CALIFORNIA COASTAL COMMISSION

**STAFF REPORT: REGULAR CALENDAR**

APPLICATION NO.: 4-97-156

PROJECT LOCATION: University of California, Santa Barbara, Main Campus -
Adjacent to Eastern Lagoon BarrierPROJECT DESCRIPTION: Expansion of the existing seawater renewal system
pumphouse, placement of two 2,500 ft. long seawater
intake lines and the construction of a 460 ft. long, 10 ft.
high, 15-32 ft. wide, rock revetment core/dune, two
stairways, access ramp and removal of 400-450 linear ft.
of existing rock revetment.SUBSTANTIVE FILE DOCUMENTS: Shown on **Appendix A****STAFF NOTE**

EXHIBIT 3
 Permit 4-97-156
 Site Plan

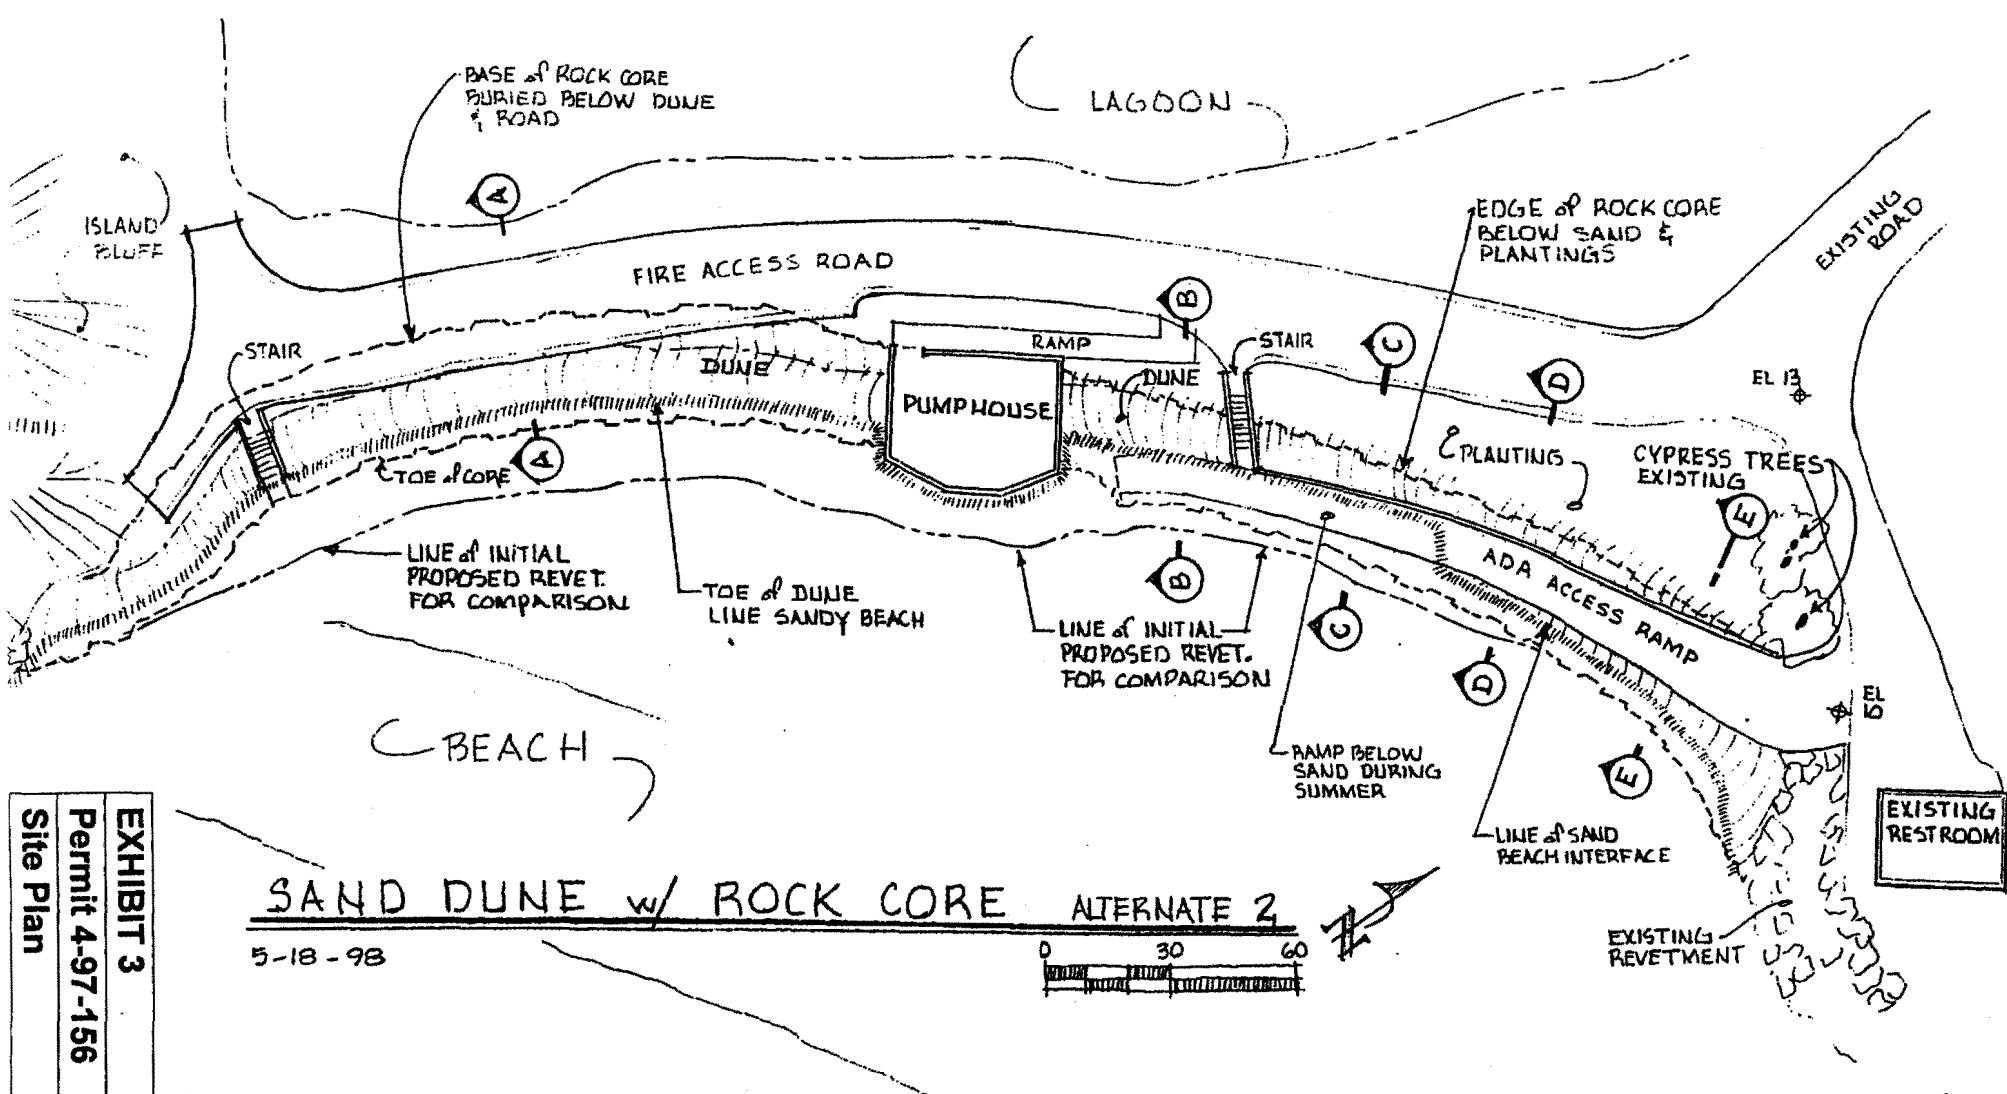
The University has now modified the originally proposed project to substitute the construction of a 460 ft. long, 10 ft. high, 15-32 ft. wide, rock revetment core/dune (Exhibit 3) for the originally proposed 460 ft. long, 10 ft. high, 15-37 ft. wide, rock

However, since the University has submitted only preliminary sketches for the proposed modification, it is not possible to accurately determine how much further landward the proposed rock revetment core/dune would be located than the originally proposed project. Staff recognizes that although the rock revetment core/dune alternative submitted by the University does appear to occupy a smaller portion of certain segments of the beach south of the pump house, the preliminary sketches submitted by the University also appear to indicate that the proposed rock revetment core/dune would occupy substantially the same amount of beach as the original proposal for all portions of the beach located to the north of the pump house. Further, staff notes that the proposed rock revetment core/dune could feasibly be located significantly further landward to the north of the pump house through relocation of the proposed ramp and relocation of the rock core revetment/dune further landward both north and south of the pump house.

Prior to the issuance of the coastal development permit, the applicant shall submit to the Executive Director for review and approval, revised plans prepared by a qualified civil engineer which delete the proposed rock revetment core/dune and the associated stairways and ramp which have been integrated into the design of the revetment. The plans shall not include the removal of the 400-450 linear feet of existing rock revetment located to the south of the proposed rock revetment core/dune.

EXHIBIT 5a
Permit 4-97-156
Revetment Details

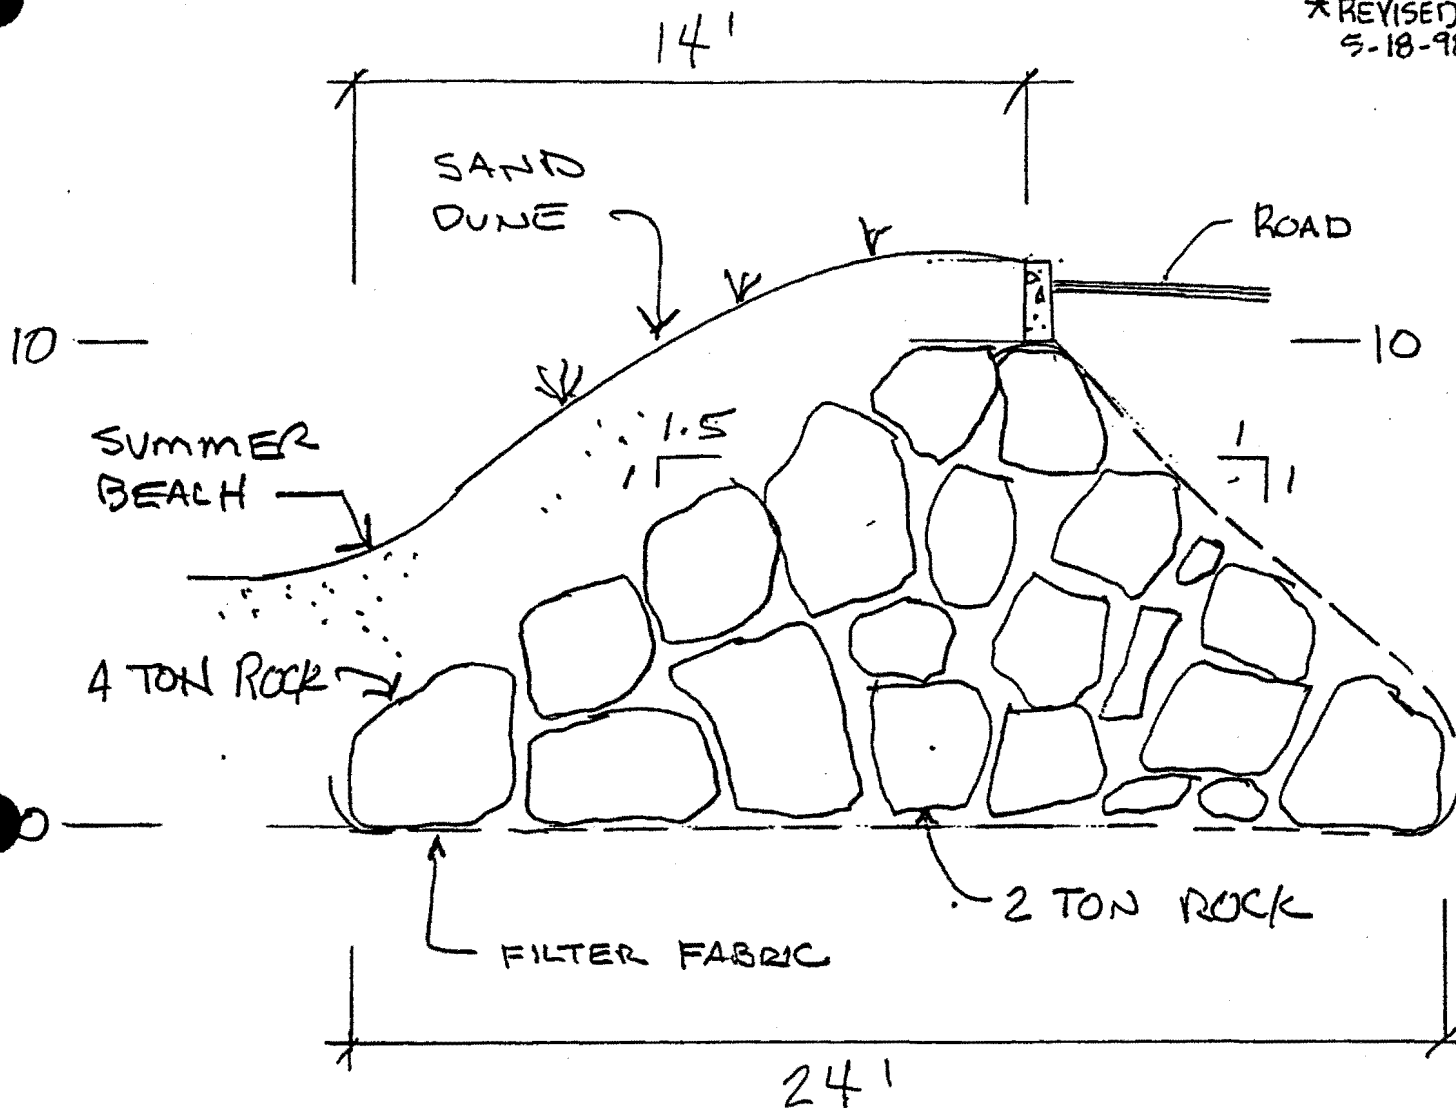
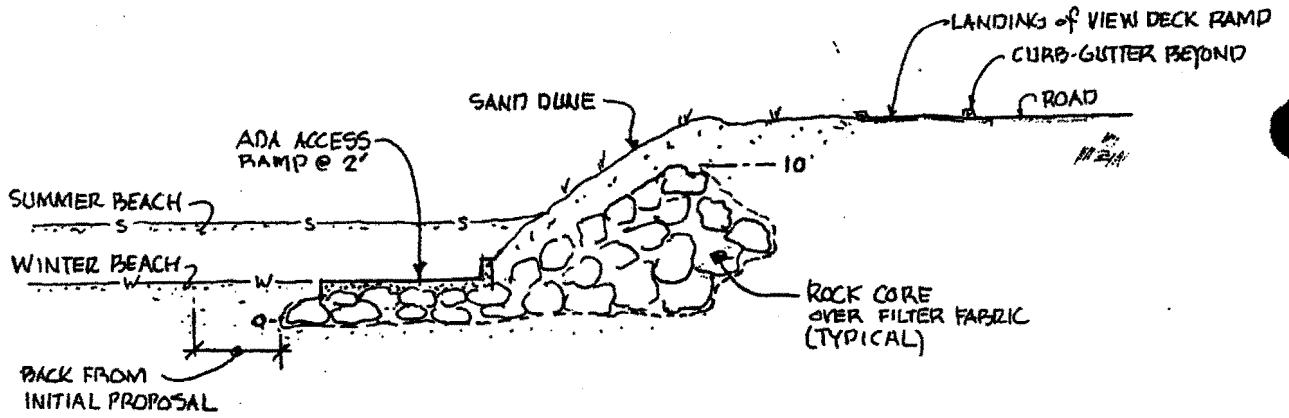
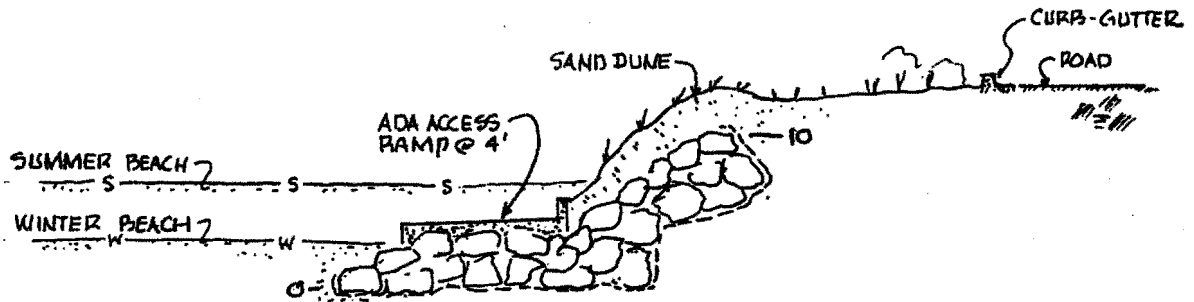
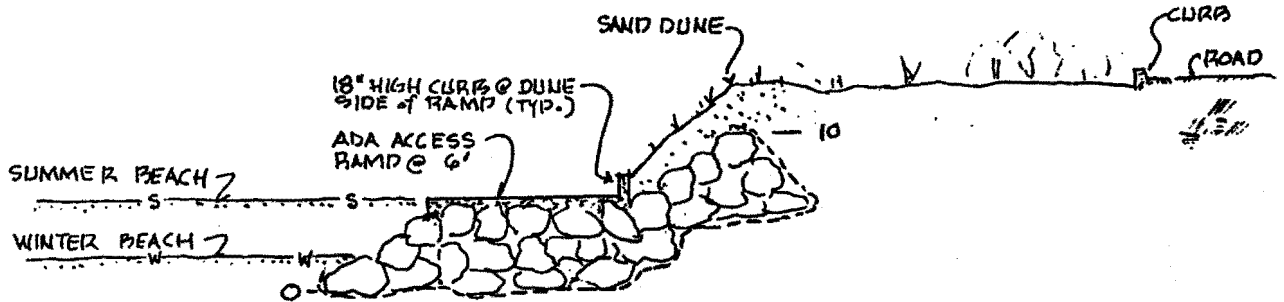
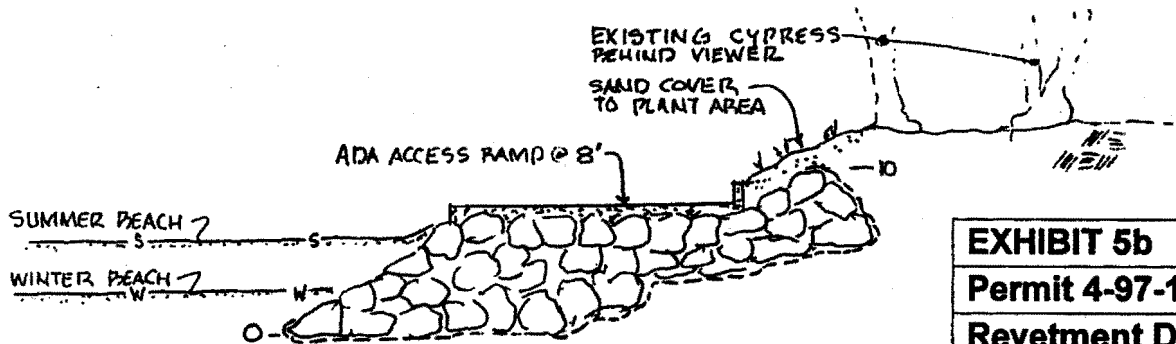
As stated previously, the University proposes to construct a 460 ft. long, 10 ft. high, 15-32 ft. wide, rock revetment core/dune to protect the pumphouse and lagoon barrier. The proposed revetment would be located seaward of the existing lagoon barrier and would connect to the existing rock revetments, which extend approximately 400 ft. both up and downcoast from the project site and serve to protect the high coastal bluffs.
